SERVICE PROCEDURE

17503

**SUBJECT: SAFETY RECALL
HEATER BOOSTER PUMP HARNESS** on certain CE school bus models built 11 May 2015 thru 20 March 2017 with feature codes 48PNW (Plastic Booster Pump), 49WXD (17k Webasto Heater), and 49MTB (Webasto Smart Temp Timer, Right of Driver).

Figure 1. Body Fuse / Circuit Breaker Panel

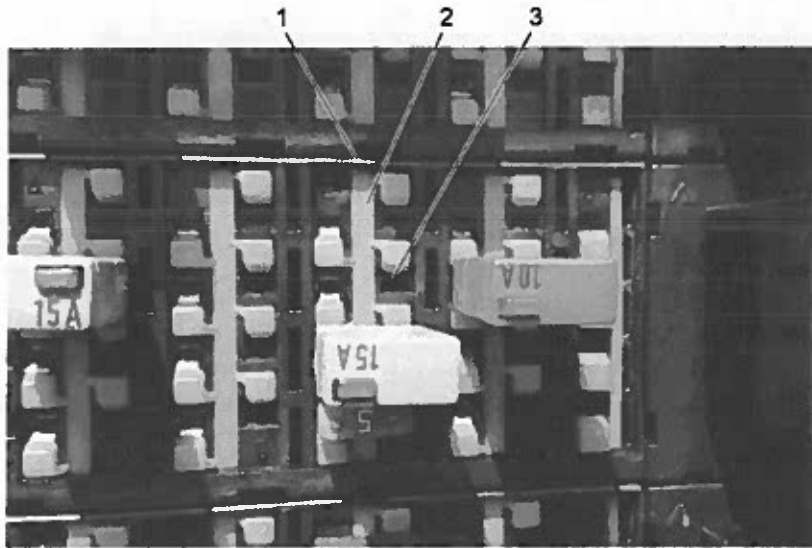
The circuit that provides electrical power to the heater booster pump may have been terminated in an unfused cavity of the power distribution center, resulting in no circuit protection. Certain types of electrical component failures within the unfused circuit may cause a vehicle fire, resulting in property damage or personal injury.

8. Locate block 10303 (Figure 1, Item 1) and remove 15A fuse / circuit breaker F29 (Figure 1, Item 2).
